Amendments to the Drawings:

Applicant : Gilbert Wolrich et al.  
Serial No. : 10/069,352  
Filed : August 7, 2002  
Page : 19 of 19

Attorney's Docket No.: 10559-308US1 / P9629US

FIG. 1

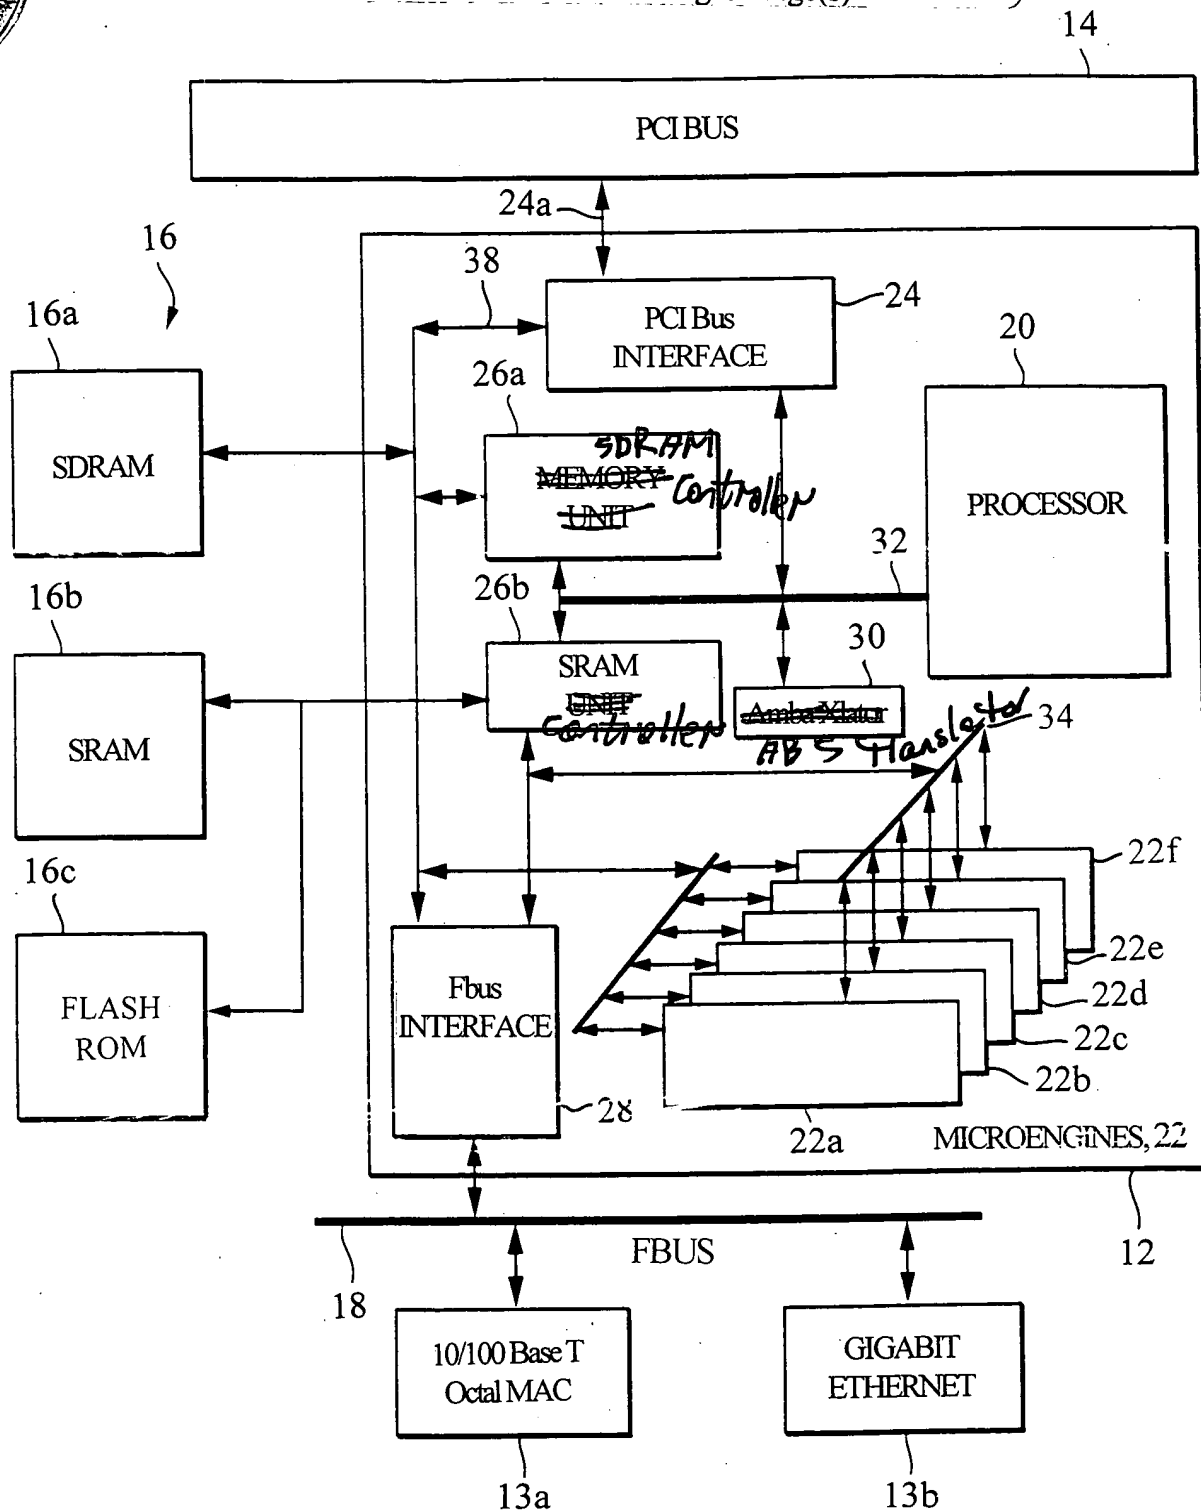
In Figure 1, the applicant changed the indicated name of the component marked 26a to "SDRAM Controller", and changed the indicated name of the component marked 26b to "SRAM Controller." Additionally, applicant has provided legible markings for the various components appearing in the figure that were deemed to have illegible markings.

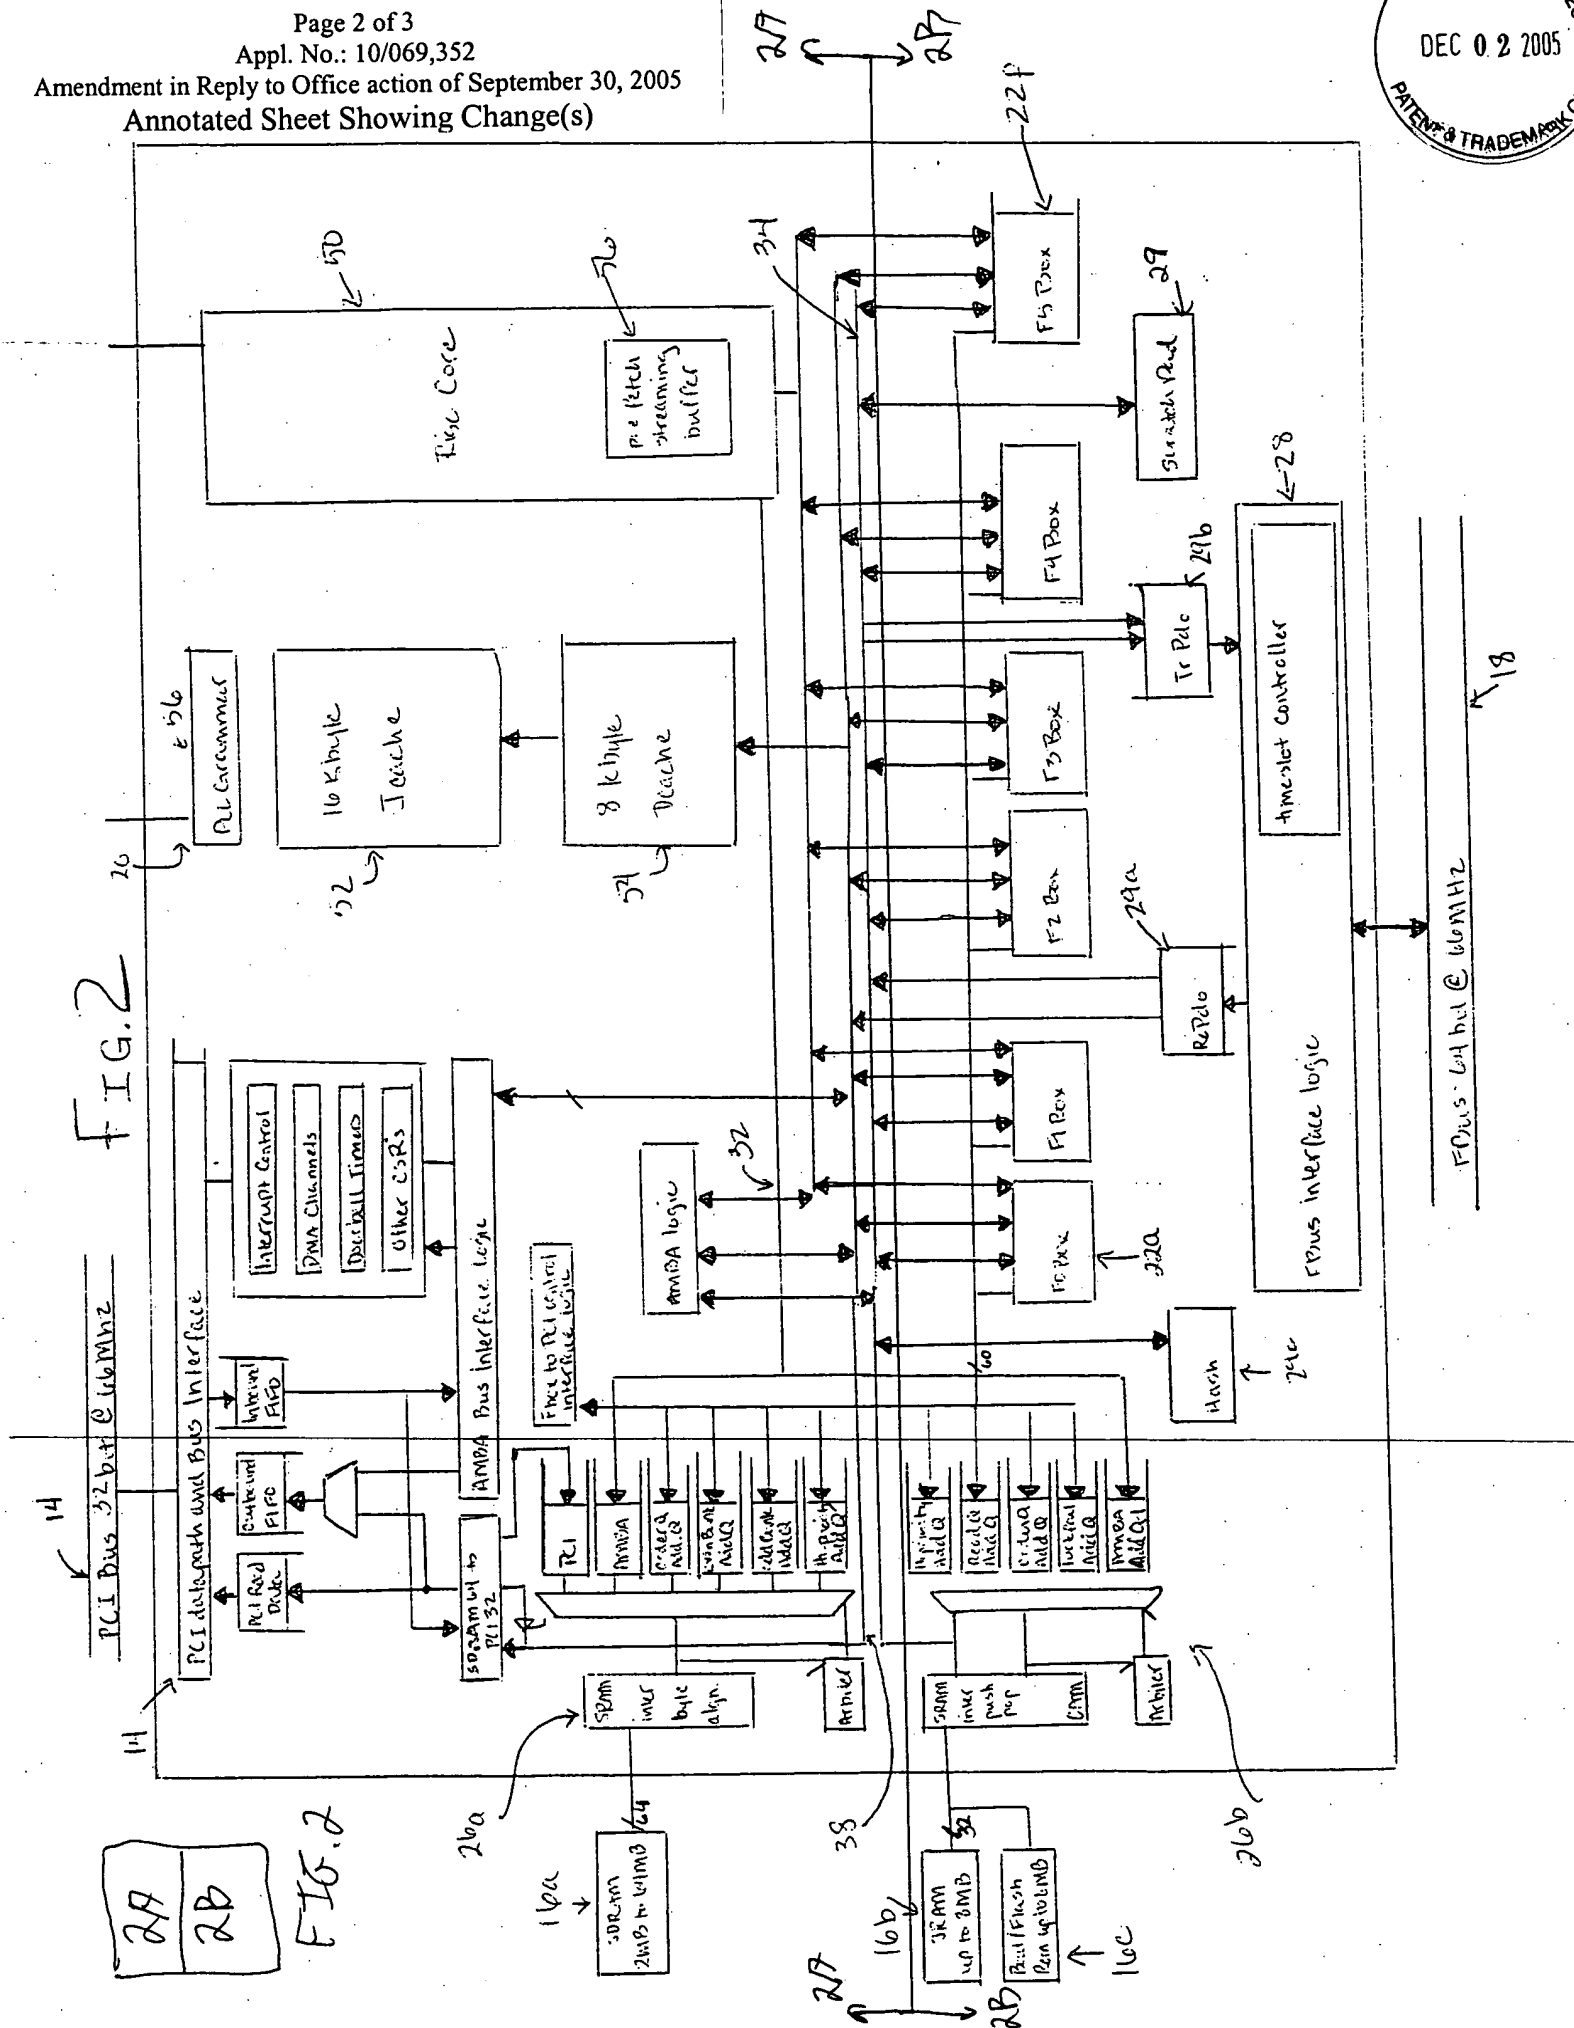
In Figure 2, the applicant presents the schematic shown in old FIG. 2 in two separate drawing sheets, Figure 2A and Figure 2B. The two replacement figures show more clearly the details shown in old Figure. 2, and conform to the statutory requirements of 37 C.F.R. § 1.84.

FIG. 3

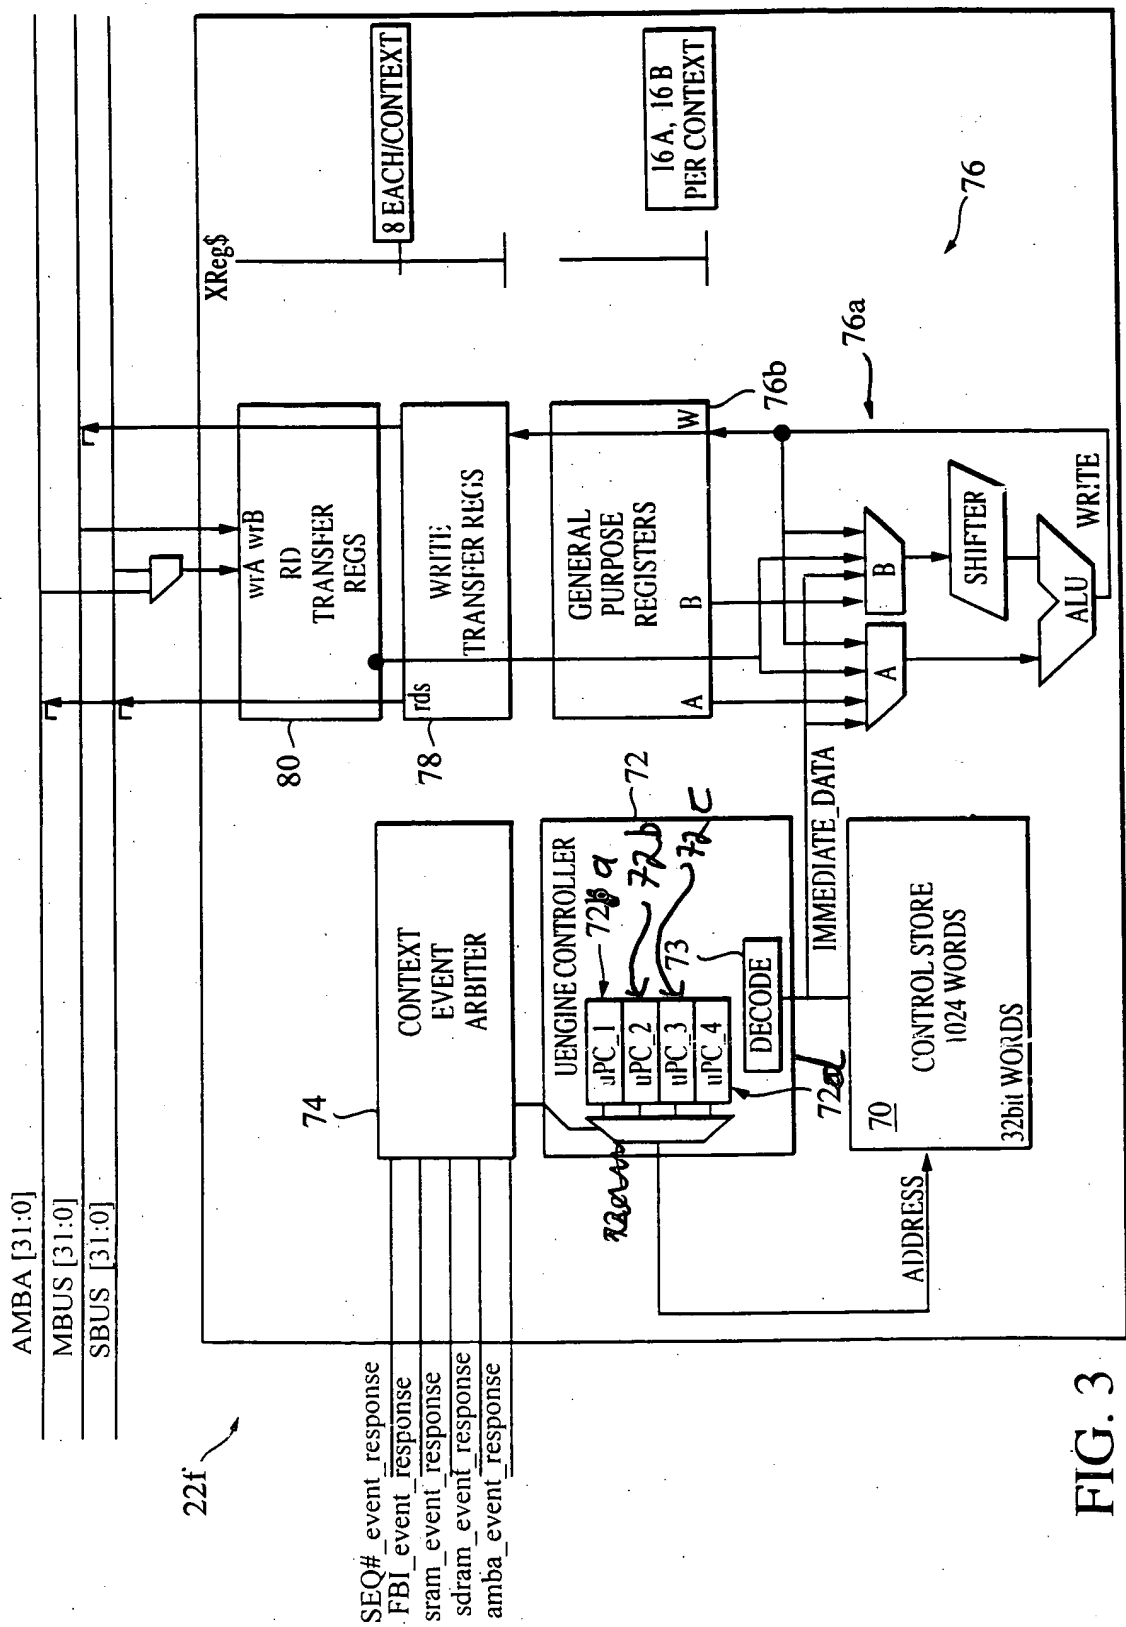
In Figure 3, the applicant marked the program counter units uPC-1 to uPC-4 with their corresponding reference numerals. Thus, uPC-1 is marked with reference numeral 72a (which previously pointed to uPC-4), uPC-2 is marked with reference numeral 72b (which previously pointed to uPC-1), and uPC-3 is marked with reference numeral 72c (which previously pointed to the illustrated multiplexer). Additionally, new reference numeral 72d was added to mark uPC-4.
